# PERMIT

SEWAGE DISPOSAL SYSTEM

SUBDIVISION Highland Lake ROAD 6591 Castleshay Lane LOT 71

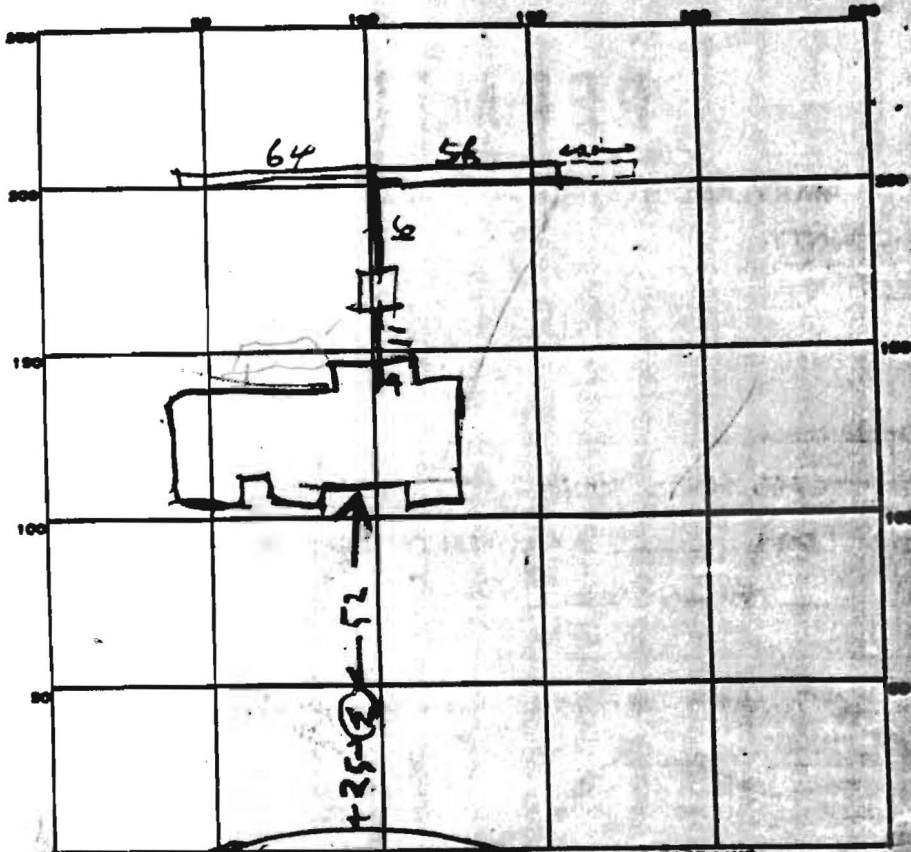
7/11/84 FS SAID COUNTY AREA BELOW 3 1/2 FT  
BUT STILL ABOUT 40 SQ FT SHORT

REMARKS 7/10/84 - TRENCH ALITTLE SHORT ON SDFPT MUST CHECK  
WITH FS OK TO COVER TANK FINISH STONE IN  
TRENCH #1. TRENCH #1 INLET 3 1/2 FT BELOW GRADE  
4 X 153 - 632 SDFPT BE PLIRED  
7/10/84 STONE ADDED TO TRENCH #1 OK TO COVER R/I  
7/11/84 FS SAID ADD 40 SDFPT (9 1/2 FT DEEP 5 FT STONE 8 FT LONG)
